## Cambridge City Council

### **WEST / CENTRAL AREA COMMITTEE**

**WEST/CENTRAL AREA COMMITTEE MEETING – 25<sup>th</sup> August 2011**  
**Pre-Committee Amendment Sheet**

ITEM: APPLICATION REF: 11/0653/FUL

**11/0726/FUL**  
**Victoria House 1 Victoria Street Cambridge Cambridgeshire**

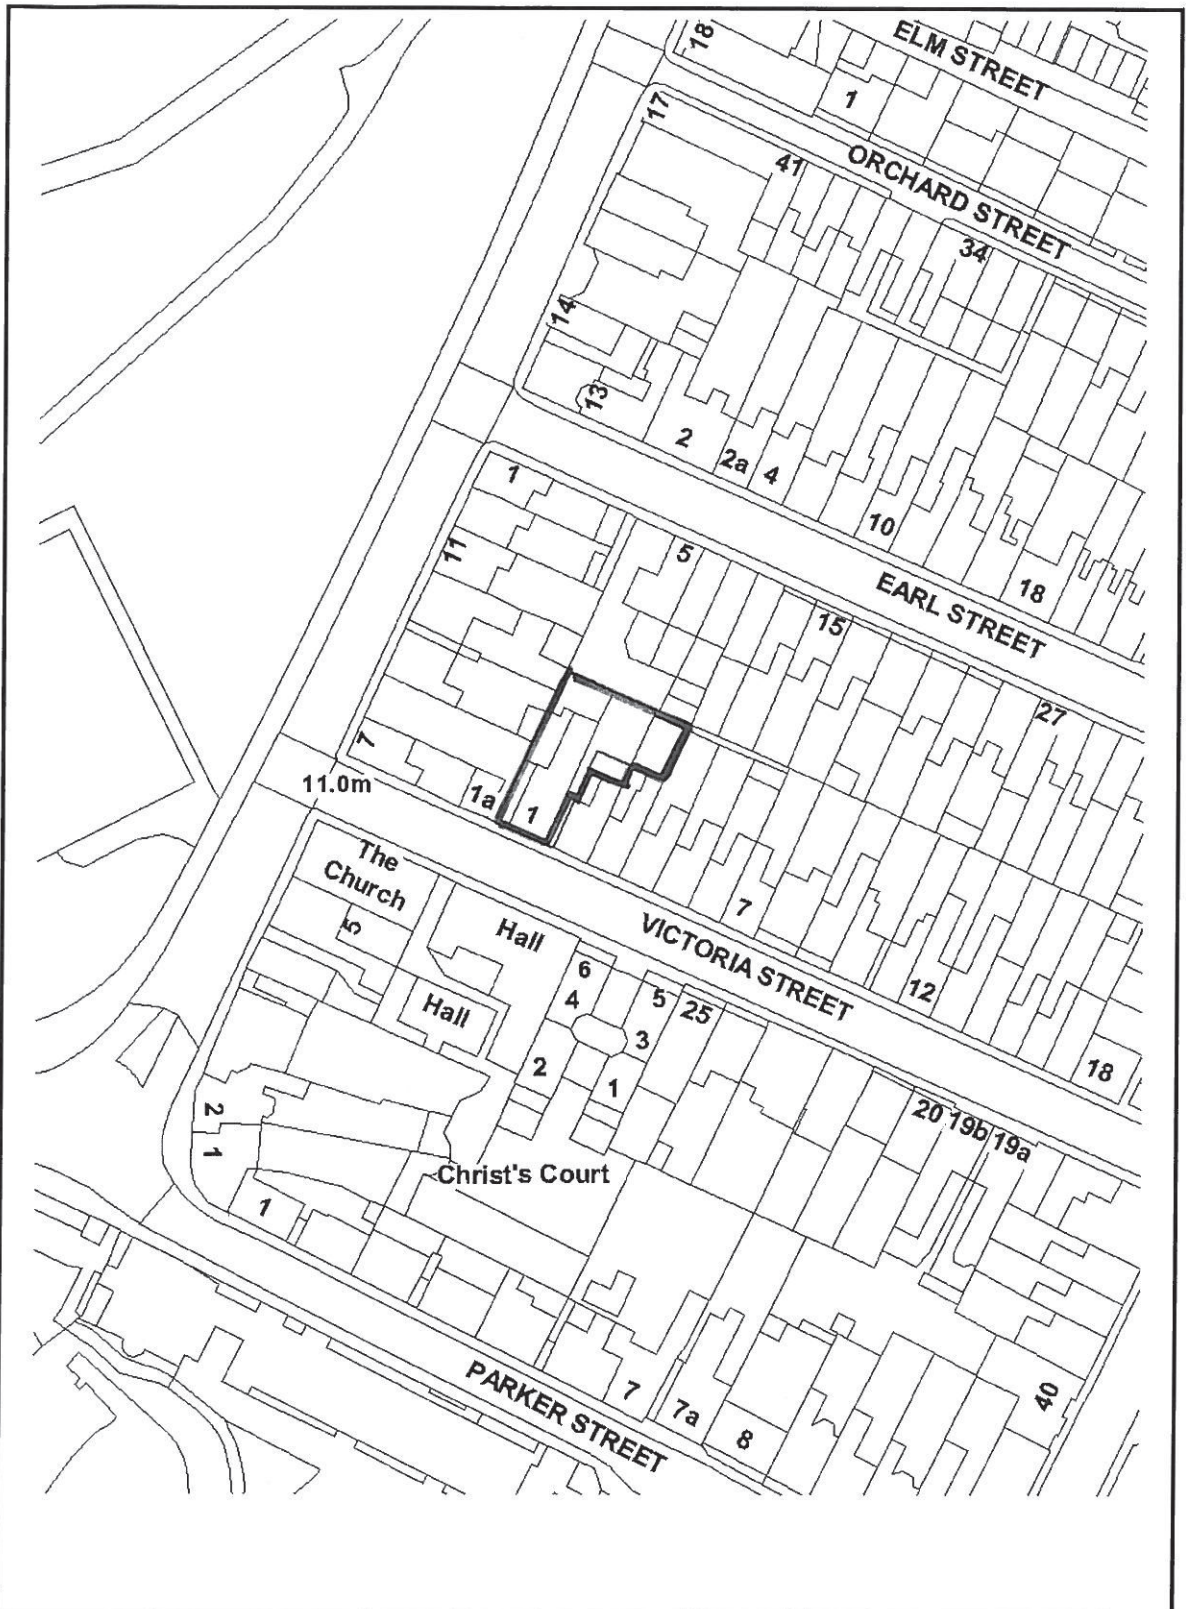
To Note: A revised car parking layout has been received and is considered to be acceptable. A copy of this is attached to the amendment sheet for convenience.

Following our telephone conversation last Friday I was delighted to hear that you will be recommending that our change of use application should be approved. I confirm that we will revise our plans to reduce the car parking allowance to two rather than four cars and I enclose an amended block plan for this. From our previous discussion I also understand that there might be a security issue relating to the boundary with 2 Victoria Street. If this is the case, I can also confirm that we are happy to improve the boundary structure to aid security.

The rear car parking area shall accommodate a maximum of 2 cars in accordance with the approved car parking details.
